ADDENDUM NO. 1

April 12, 2021

HANOVER CENTRAL HIGH SCHOOL ADDITIONS AND RENOVATIONS Cedar Lake, IN 46303

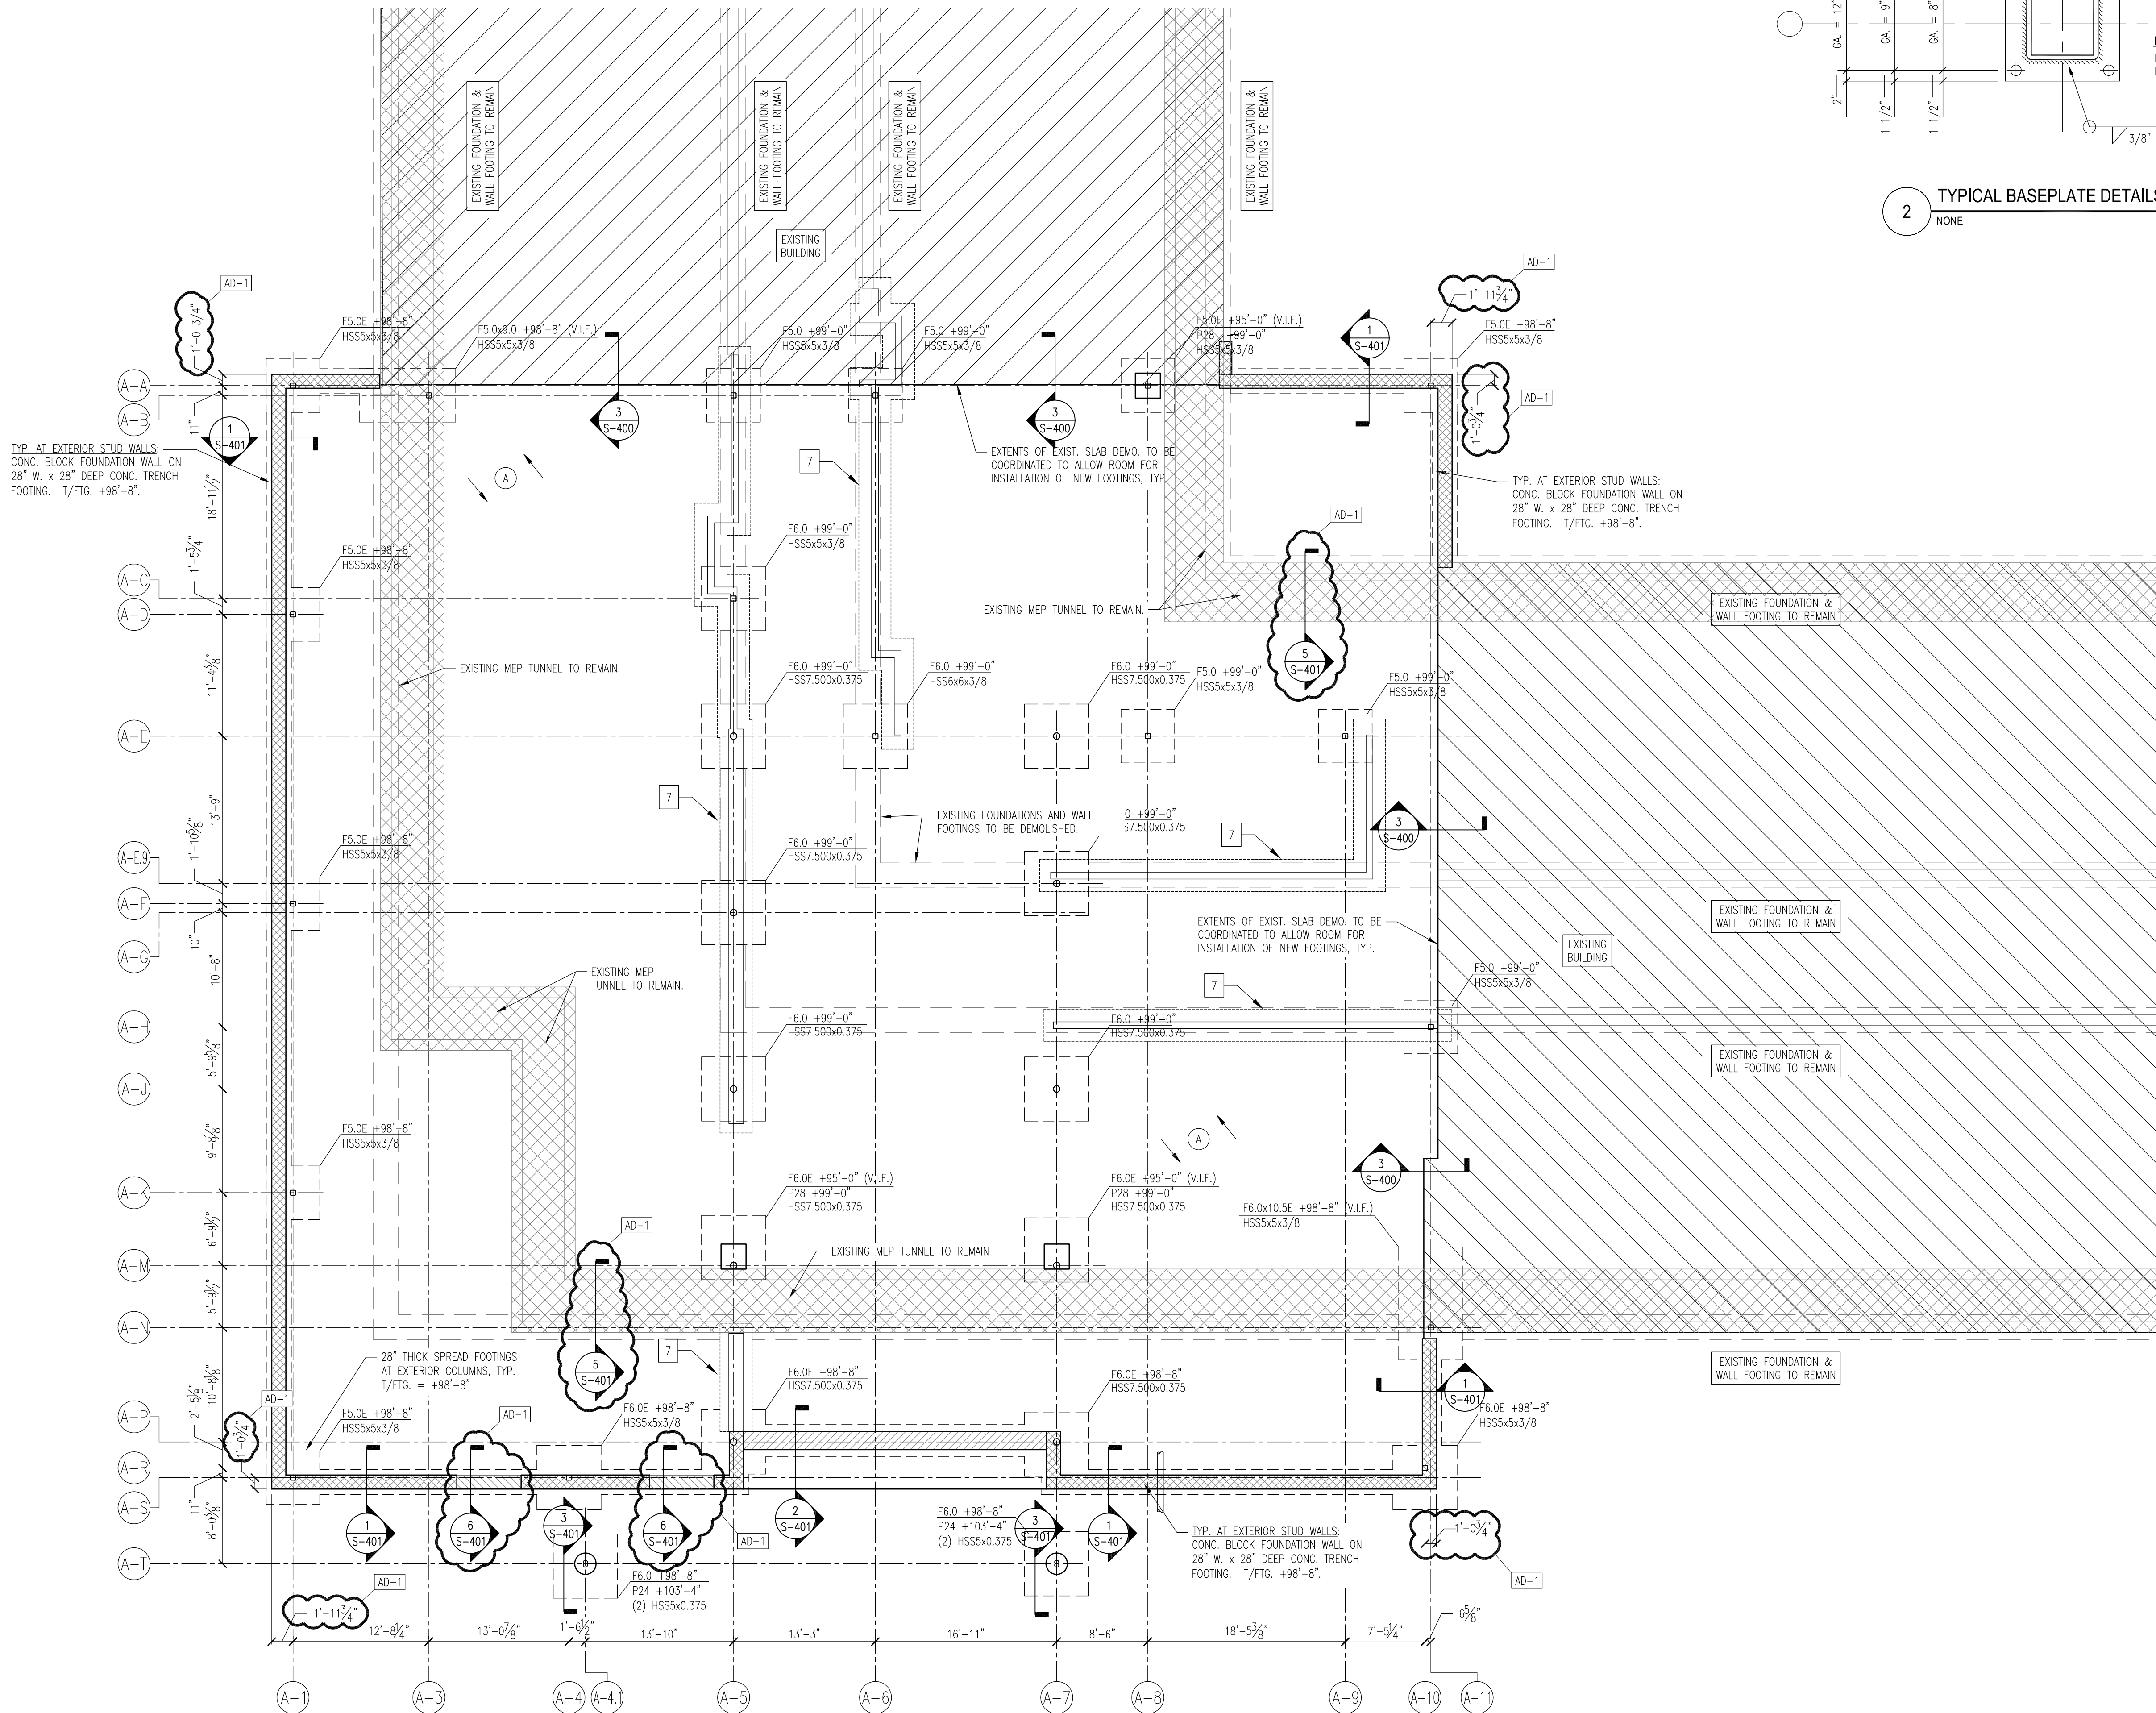
- A. Refer to revised full size drawing, included in this Addendum, for revisions.
 - 1. Change note at existing Band Room tiered seating to read "See Note 2" of the general notes on the same sheet.
 - 2. On general notes, add a reference to new Section 7/S-401.
